# Access Compliance Report

### (Curb Ramps)

Intersection ID: 11780	Main Street: E_20TH_ST	Cross Street: PEGRAM_ST	Location: W
ADA ID: 6EEB1E694031	Ramp Type: BlendTrans2	Initial Pass/Fail: Fail	Overall Compliance: No
Severity Score: 25			
Codes/Mitigation Info/Possible Solution		Field Measurements/Component Compliance

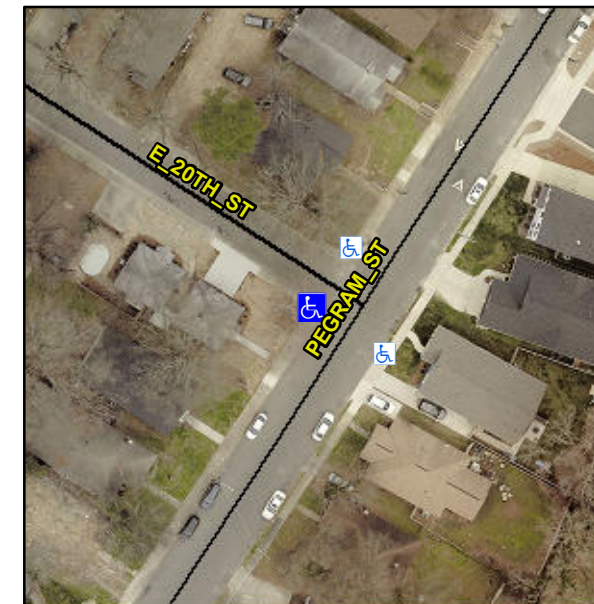
Compliance	Description	Data	Compliance	Description	Data
N/A	Ramp Length (in)	47.5	Yes	BlendTrans Slope (%)	2.9
Yes	Ramp Width (in)	49.5	No	BlendTrans XSlope (%)	11.3
N/A	Flare Type LT	N/A	N/A	Flare Type RT	N/A
N/A	Flare Slope LT (%)	N/A	N/A	Flare Slope RT (%)	N/A
N/A	Flare Traversable LT?	N/A	N/A	Flare Traversable RT?	N/A
N/A	Landing Length (in)	N/A	N/A	DWS Provided?	N/A
N/A	Landing Width (in)	N/A	N/A	DWS Contrast?	N/A
N/A	Landing Slope (%)	N/A	N/A	DWS Length (in)	N/A
N/A	Landing X Slope (%)	N/A	N/A	DWS Full Width?	N/A
N/A	Landing Curb? (Y/N)	N/A	N/A	DWS Offset (in)	N/A
N/A	Shared Landing?	N/A			
N/A	Gutter Ponding?	N/A	N/A	Gutter Slope (%)	N/A
N/A	Gutter Lip Ht (in)	N/A	N/A	Gutter X Slope (%)	N/A
N/A	Painted X Walk1?	No	N/A	Painted X Walk2?	No
	X Walk 1 Direction	To SE		X Walk 2 Direction	To NE
	X Walk 1 Width (in)	N/A		X Walk 2 Width (in)	N/A
	X Walk 1 Slope (%)	2.8		X Walk 2 Slope (%)	5.0
	X Walk 1 X Slope (%)	3.1		X Walk 2 X Slope (%)	0.0

**Remove & Replace Curb Ramp With Two New Directional Ramps or Equivalent.**
